C8051F55x-56x-57x Errata

Errata Status Summary

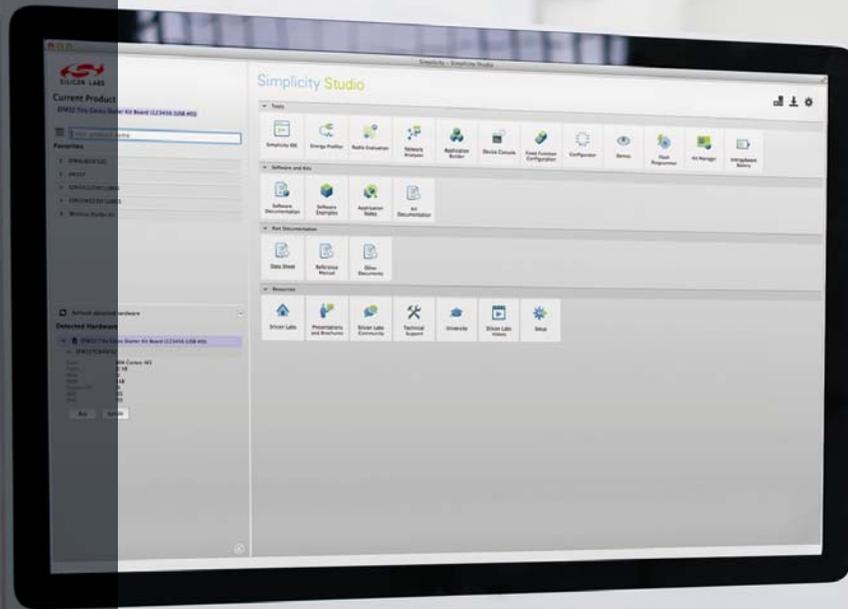
- Description:** If the /RST pin is held low for more than 1 second while power is applied to the device, and then /RST is released, a percentage of devices may “lock up” and fail to execute code. Toggling the /RST pin does not clear the condition. The condition is cleared by cycling power. Most devices that are affected will show the lock up behavior only within a narrow range of temperatures (a 5 to 10 degrees C window).

Impacts: Devices that lock up due to this issue will fail to execute code until the next power-on reset.

Resolution: Silicon Labs has identified a solution to this problem and this solution has been tested and qualified. Parts with the fix do not have any restrictions on /RST low time. The silicon revision remains the same, but Revision A parts that implement the fix can be identified visually using the assembly date code marking on the device. A four-digit assembly build date code is marked on each part on the bottom-most line. This is in the format YYWW, where YY is the two-digit assembly build calendar year and WW is the two-digit assembly build work week. All parts that have an assembly date code of 1124 or later (year 2011, work week 24) do not have any restrictions on /RST low time.
